SUBDIVISION COMMITTEE
METROPOLITAN AREA PLANNING COMMISSION

STAFF REPORT
(Final Plat)

CASE NUMBER: S/D 95-80 CRIGLER ADDITION

VICINITY MAP:

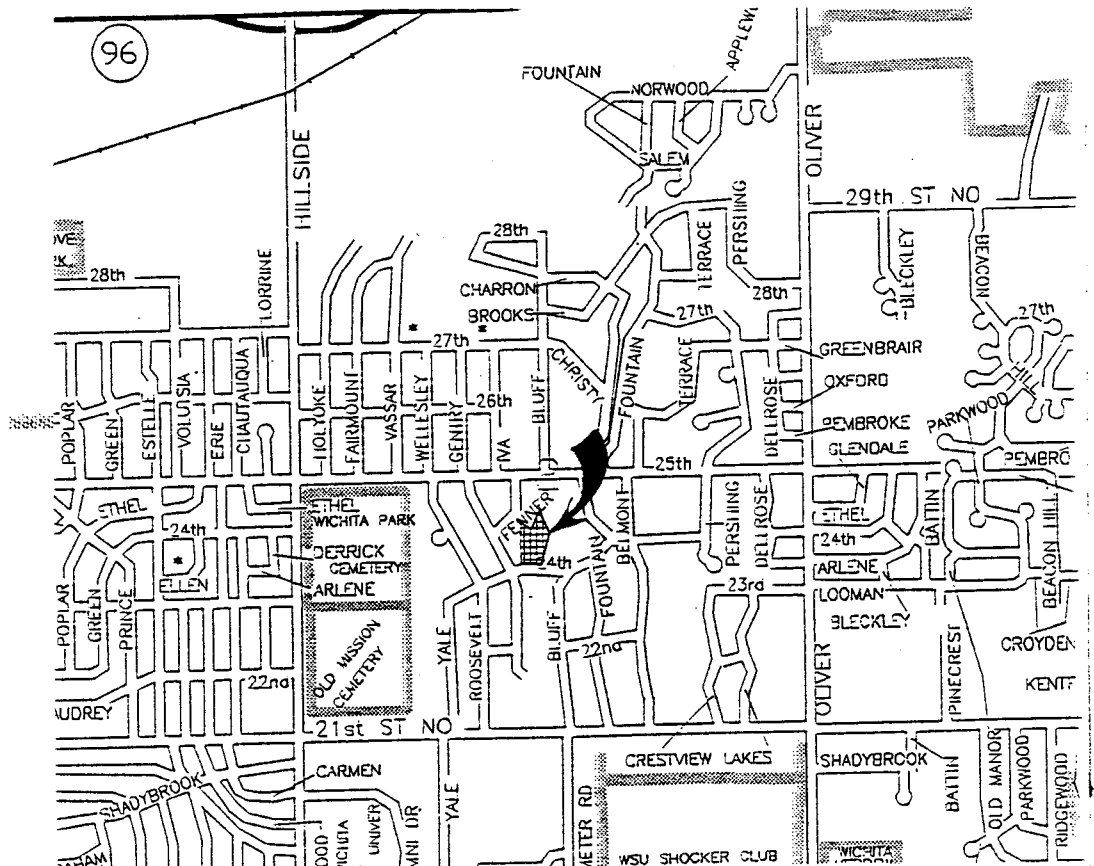
- E. On the final plat tracing, the common lot line between Lots 1 and 2 shall be drawn at the same thickness of the other lot lines. As now drawn, it is somewhat uncertain as to line being a lot line or just a center line for the adjacent 20-foot easement.

- F. On the final plat tracing, it appears that a tie point from one of this Addition's lots (Lot 1) can and should be established from an adjacent existing lot.

- I. The applicant's agent is advised that while the street to the northwest of this site was platted as Ethel, recent maps are showing all or the north-south section as having the name Fenner (Place). The final plat tracing shall correctly indicate the name(s) for this street segment.

- O. The representatives from City Engineering should be prepared to comment on the status of the applicant's drainage plan.
- P. The applicant's agent should be prepared to describe the ownership situation for the unplatted tract from which these lots are being created. Of primary concern is if any property is becoming landlocked due to this plat and the narrow, triangular piece of property along the northwest line of Lot 1.
